SAFETY EVALUATION BY THE OFFICE OF NUCLEAR REACTOR REGULATION

SUPPORTING AMENDMENT NO. 10 TO FACILITY LICENSE NO. DPR-6

BIG ROCK POINT PLANT

DOCKET NO. 50-155

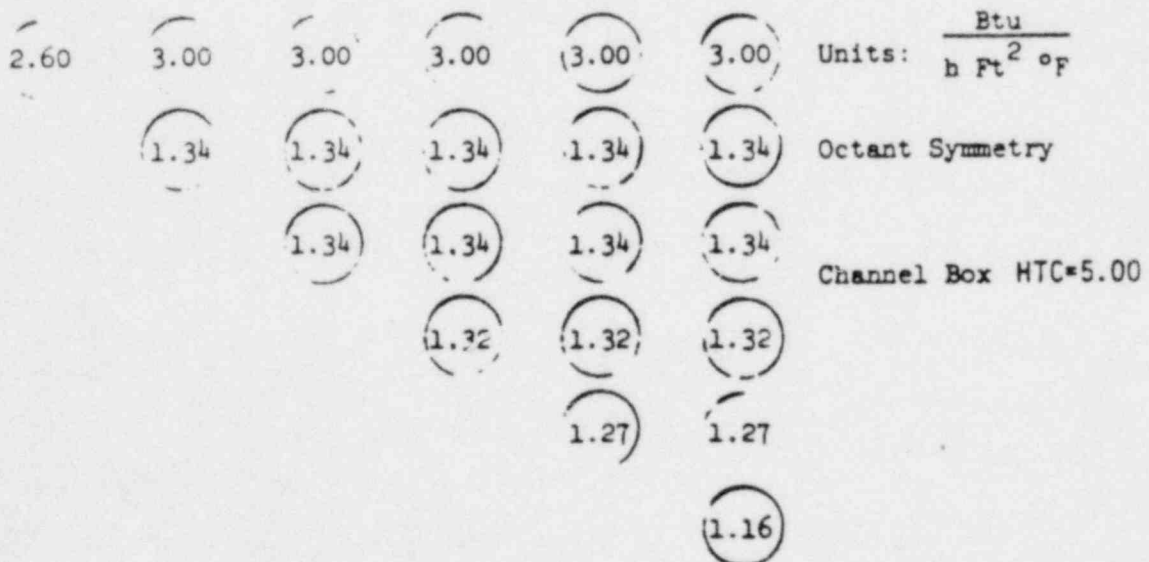
The core spray heat transfer coefficients used in the General Electric fuel heatup analysis are shown below for one octant of the 9 x 9 array:

The method of assignment of these heat transfer coefficients (HTCs) is taken from the Appendix K prescription for 7 x 7 fuel (Section I.D.6.b):

The extension of this prescription to the 9 x 9 array is considered conservative and has been used in the past for Big Rock Point. It yields a lower rod average heat transfer coefficient for the 9 x 9 array when compared to that for the 7 x 7 array:

Since the use of lower HTC's in this portion of the heatup analysis produces higher peak clad temperatures, the choice of the above HTC's for the 9 x 9 array is justified. Similar calculations lead to the conclusion that the rod average heat transfer coefficient for the 8 x 8 array is lower than that for the 7 x 7 array. The use of these heat transfer coefficients was shown to be conservative for use in the prediction of the peak clad temperature for full-length bundles during simulated LOCA transient experiments (Ref: J. D. Duncan and J. E. Leonard, "Modeling the BWR/6 LOCA: Core Spray and Bottom Flooding Heat Transfer Effectiveness," NEDE-10801, March 1973).
